CERTIFICATE OF APPROPRIATENESS

Property: 400 Westmoreland, Lot 10, Tract 9, Block 6, Westmoreland Subdivision. The property includes a Noncontributing 12,938 square foot, two-story brick and vinyl clad 16-unit apartment complex situated on a 10,000 square foot (80' x 125') corner lot.

Proposal: Alteration – Cladding, Windows, and Signage *Noncontributing*

NORTH ELEVATION – FRONT FACING WESTMORELAND STREET
EXISTING

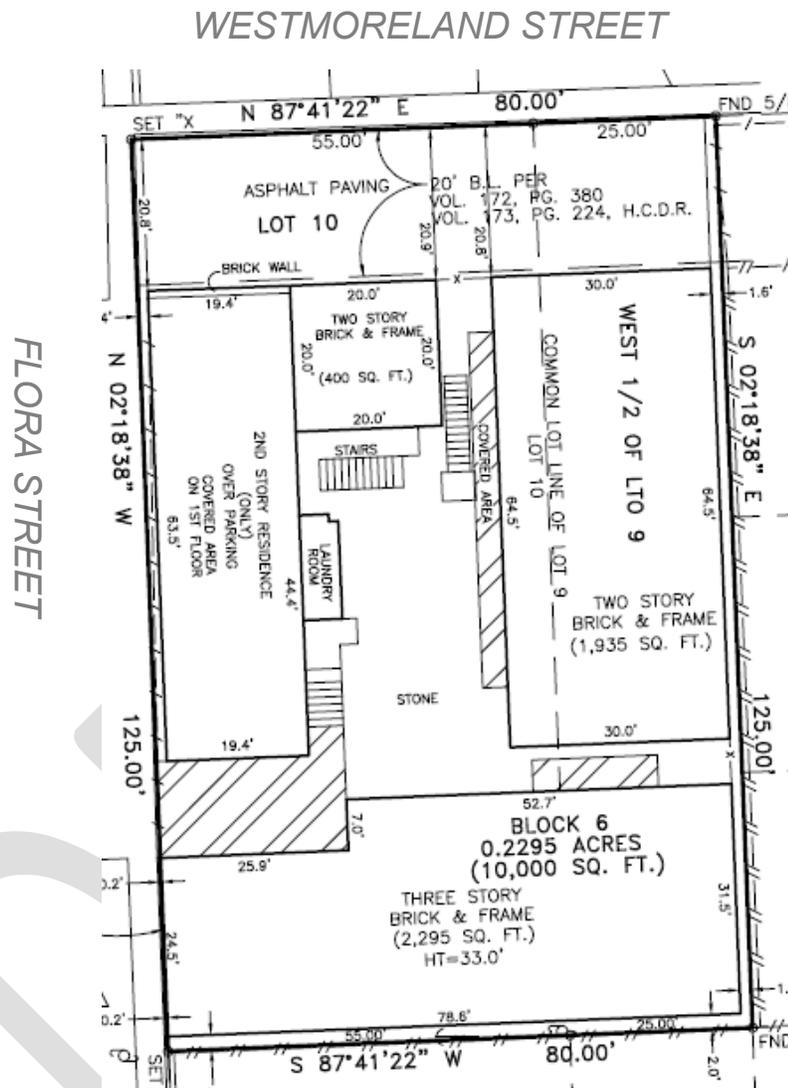
Recommendation: **Partial Approval: Approve the window replacement, paint, and installation of vertical metal siding. Deny the installation of horizontal cedar siding and altering the roof shape on the north elevation.**
